# LSC Responses to TIS Redline Comments

This TIS supports the Sterling Ranch East - Phase 1 Preliminary Plan (SP224)

## Sterling Ranch East - Phase 1 Rezoning & Preliminary Plan Traffic Impact Study (LSC #S224510)

SP-22-004, P-22-012, P-22-013

**Table 6**  
**Roadway Segment Improvements**  
**Sterling Ranch East Phase 1 Preliminary Plan**  
 (page 1 of 2)

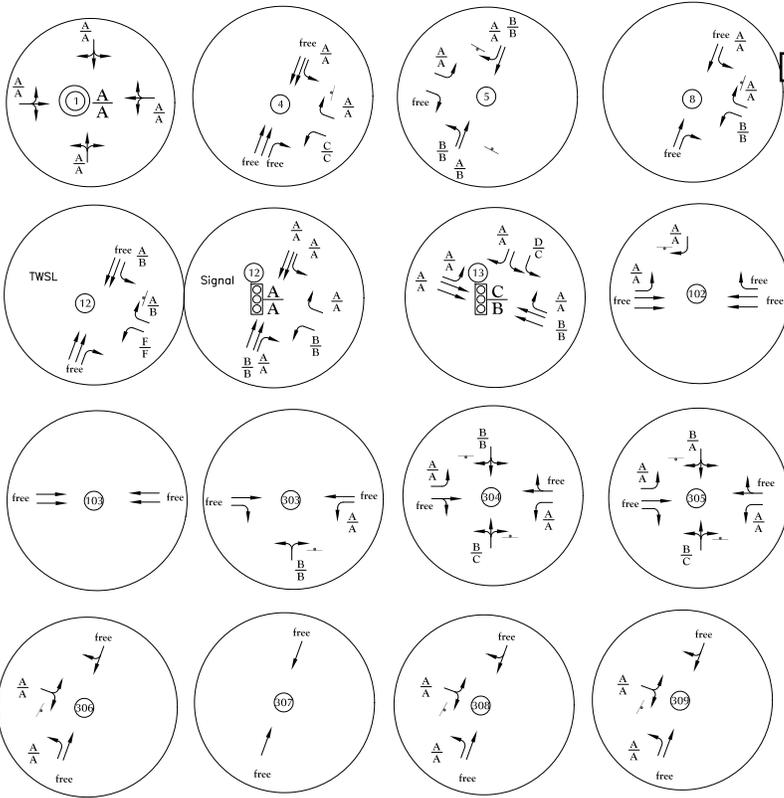
Removal of bike lane not appropriate when it will be restored later (Master TIS comment)

Trigger? (Master TIS comment)

By other

Sterling Ranch with potential County assistance with ROW acquisition

LSC Response: This table has been revised based on conversations with the City of Colorado Springs. It is consistent with the updated February 10, 2023 Sterling Ranch Master TIS.

LSC Response: The triggers are listed in the preceding line item under design ADT (directional northbound and southbound).

LSC Response: This line item has been revised in both this report and the February 10, 2023 Master TIS per EPC Staff comment on the Master Study.

LSC Response: Modified as requested.

Figure 14c  
Short-Term Total Lane Geometry,  
Traffic Control, and Level of Service

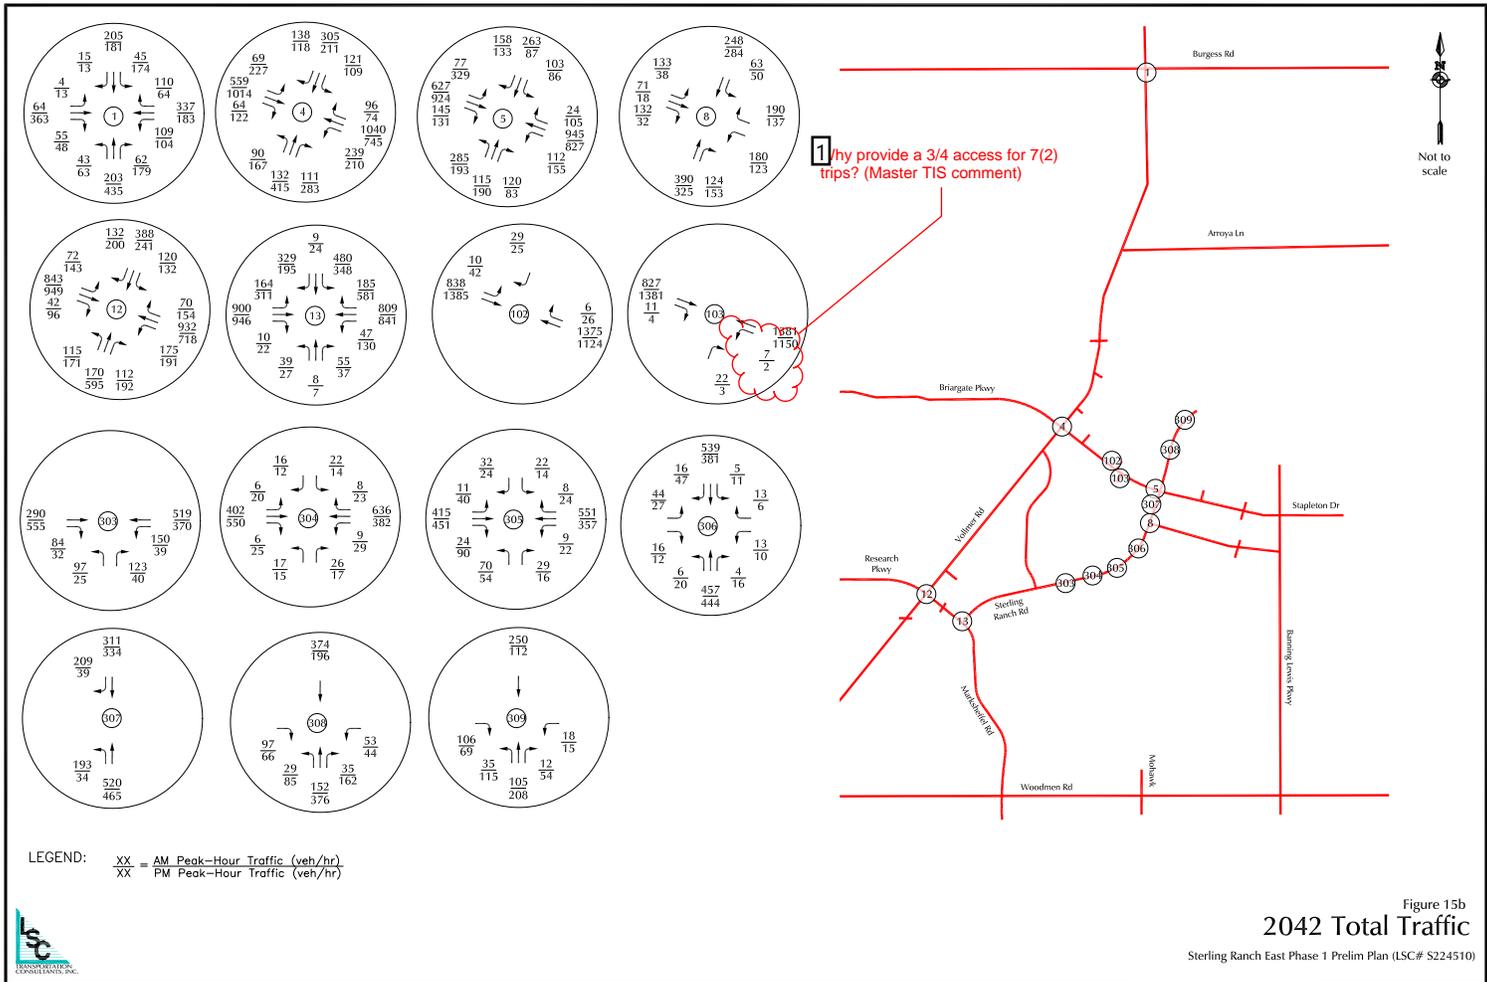
Please use a more appropriate analysis tool for roundabout operations (Master TIS comment)

LSC Response: LSC contends that the HCM methodology is appropriate for this planning level of analysis and provides a reasonable prediction of future LOS. This has been discussed with Staff. Once this intersection enters the design phase, detailed roundabout reports will be required that will utilize Rodel (most likely).

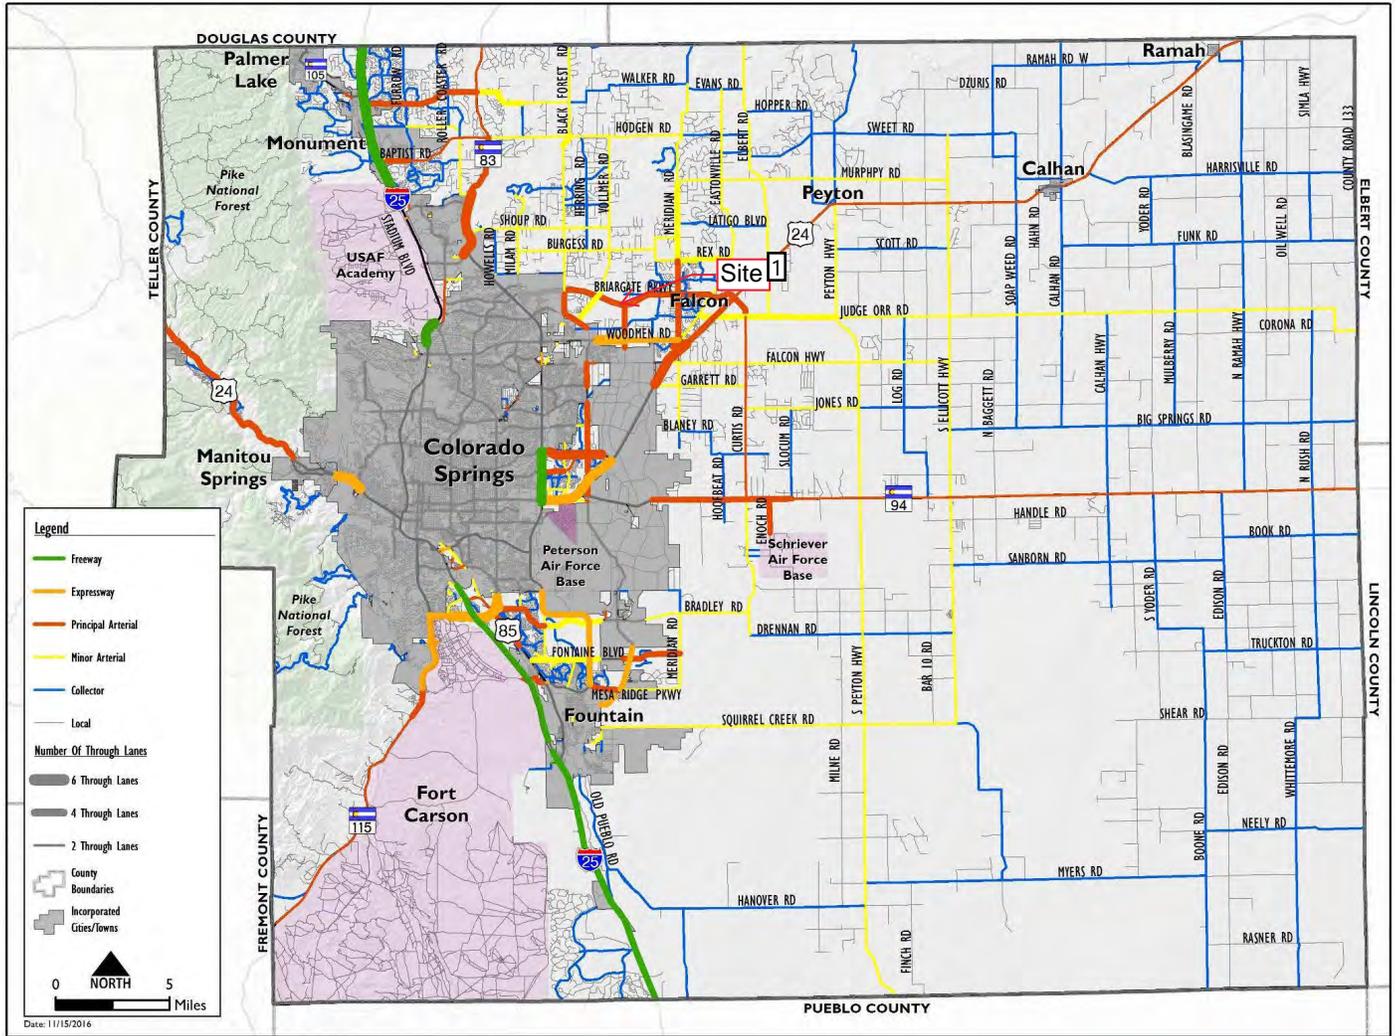
Why provide a 3/4 access for 7(2) trips? (Master TIS comment)

LSC Response: Intersection #103 is needed to serve the future K-8 school site. There are currently no plans available that show the school layout and access plan. This TIS assumed the access to Briargate Parkway would serve a bus loop only. However, this intersection is requested as a 3/4 movement access to provide flexibility as actual designs are prepared for the school.
